# PRODUCT CHANGE NOTIFICATION

### Select Bourns® 1430 and 1440 Series Surge Protective Devices

#### *Change in Printed Marking on Module and Base*

SPD2502

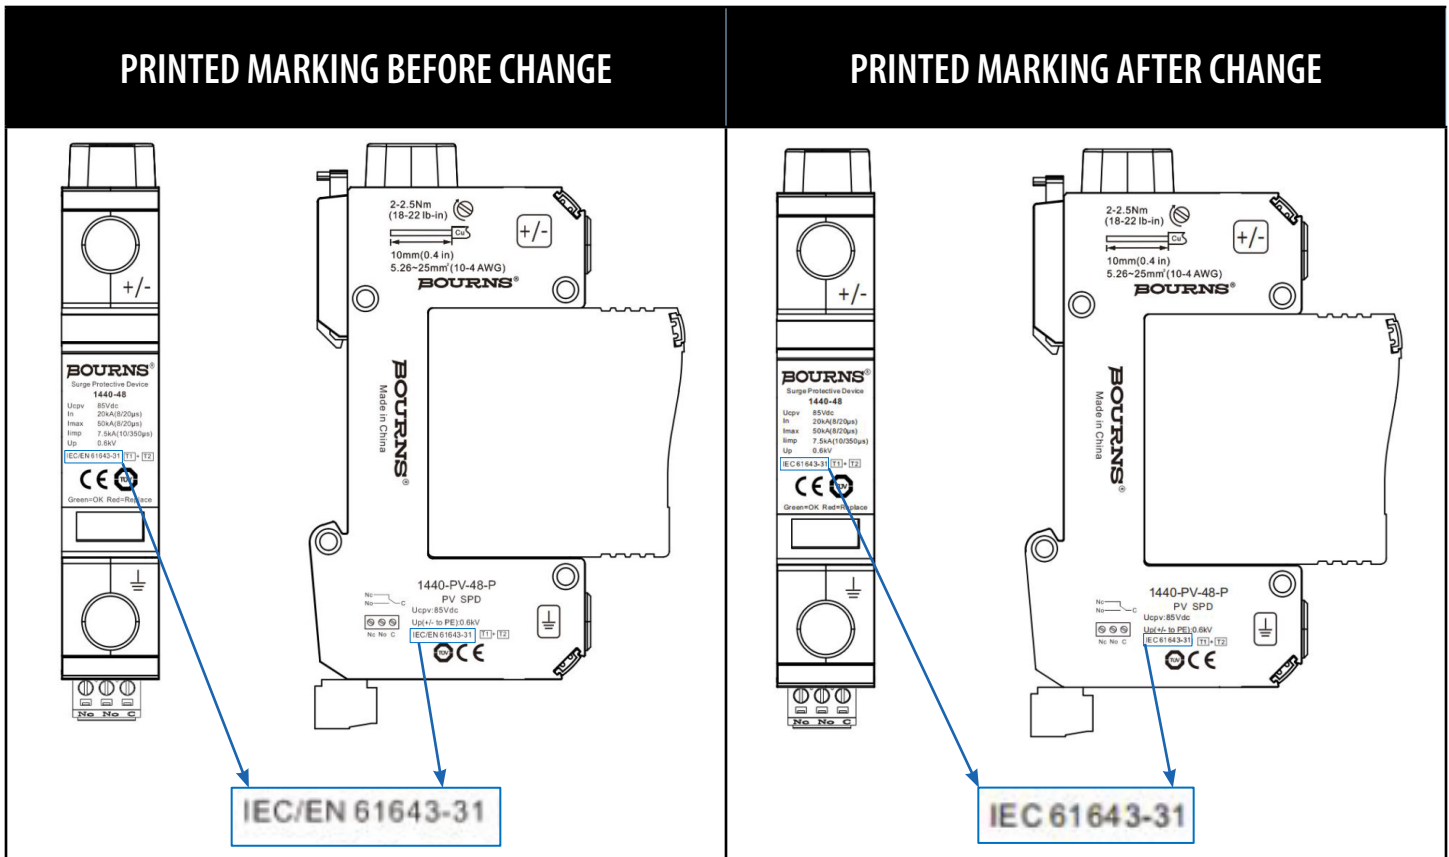
Riverside, California – February 14, 2025 – To conform with updated TÜV certificate requirements for the Bourns® [1430](#) and [1440](#) Series Surge Protective Devices, effective April 1, 2025, Bourns will update the printed marking on these models. The printed marking on the module and base of the affected part numbers will change from “IEC/EN 61643-31” to “IEC 61643-31”.

This change in marking will affect the form of the product. The fit, function, quality and reliability of the affected part numbers will remain unchanged. The product specifications will not change. Traceability will be maintained through lot code and date code.

- Date that the use of the current marking will cease: **April 1, 2025**
- Date that the use of the new marking will begin: **April 2, 2025**
- First date codes using the above changes: **2513**
